UNITED STATES PATENT AND TRADEMARK OFFICE

APPLICATION NO.	FILING DATE	FIRST NAMED INVENTOR	ATTORNEY DOCKET NO.	CONFIRMATION NO.
09/759,579	01/12/2001	Robert F. Heard	91805001	1809

Office Action Summary

DETAILED ACTION

FIG 9

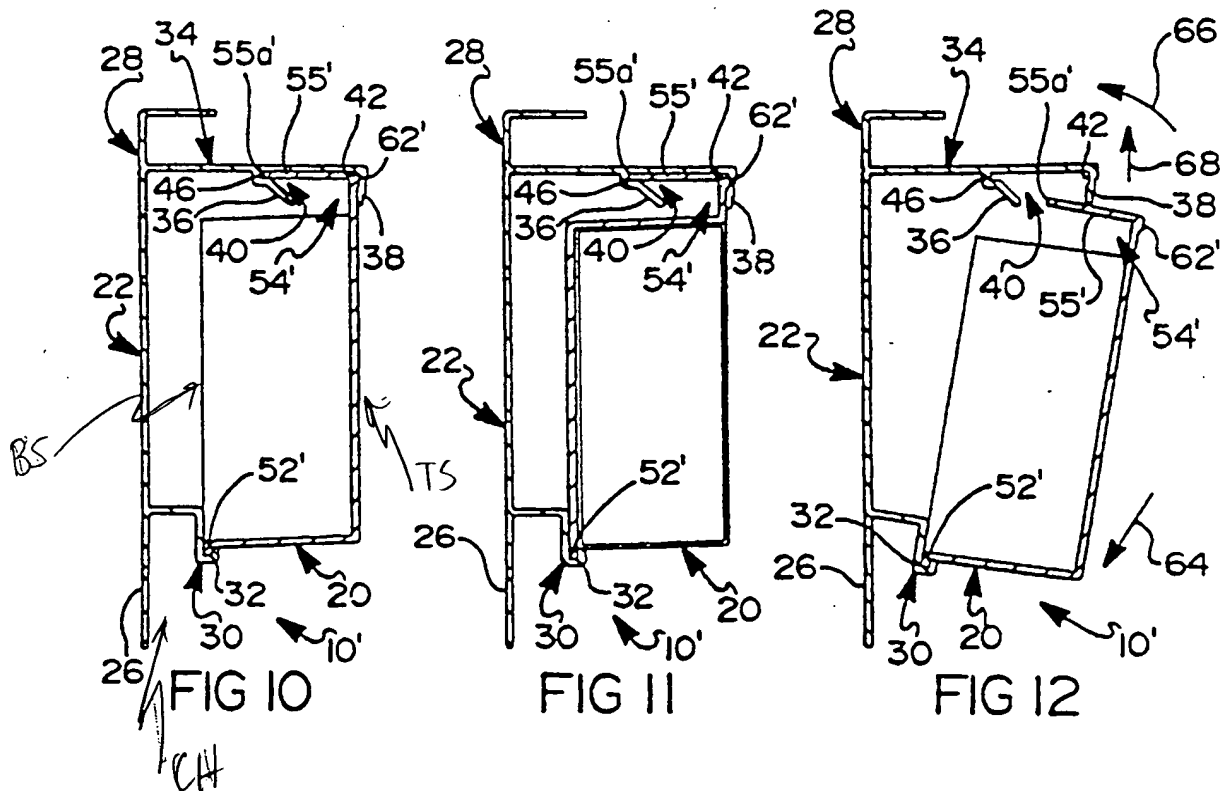
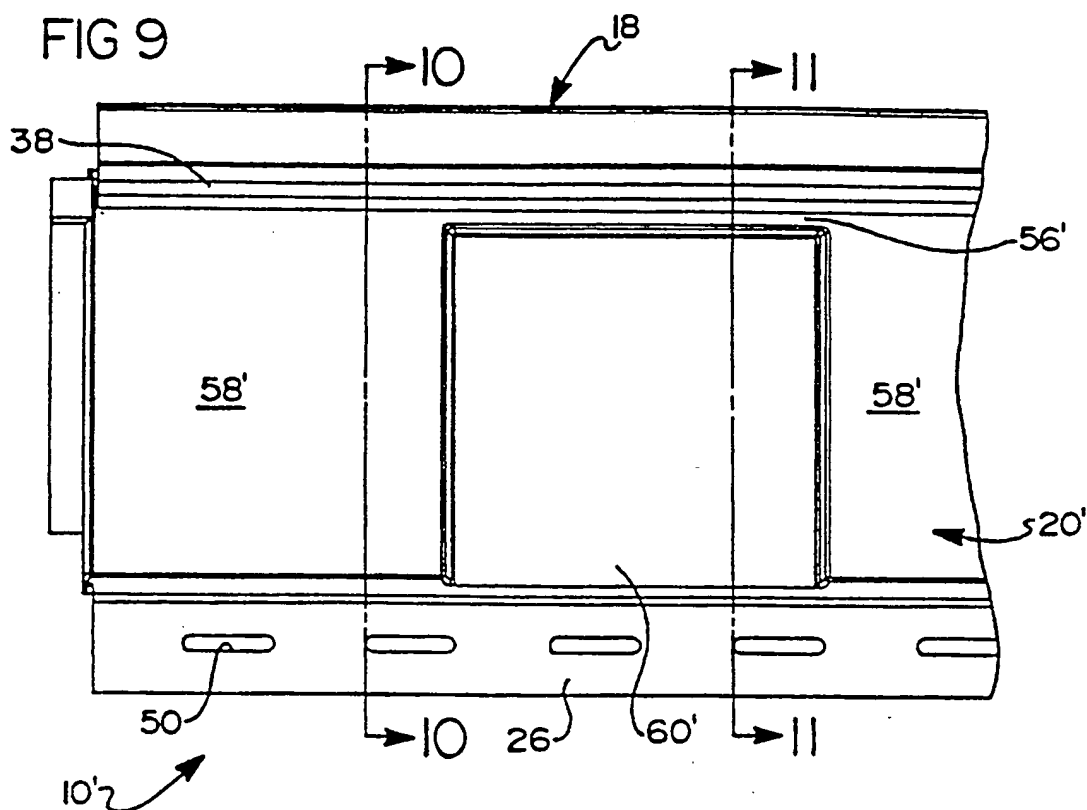
4. Claim 18 is rejected under 35 U.S.C. 103(a) as being unpatentable over US Patent #5,090,174 to FRAGALE. As discloses in paragraph 6 above, FRAGALE discloses the basic claimed brickmolding except for explicitly stating that the fastener is received within a hole. Although a hole is not shown or discussed, it would have been obvious to one having ordinary skill in the art at the time the invention was made to provide the flange of FRAGALE with openings/holes in order to more readily receive fasteners therethrough.

In regards to the applicant's argument that the device of FRAGALE does not have a "substantially solid rectangular portion", the figures clearly shows a rectangular portion (104) that is a "solid rectangular" portion.
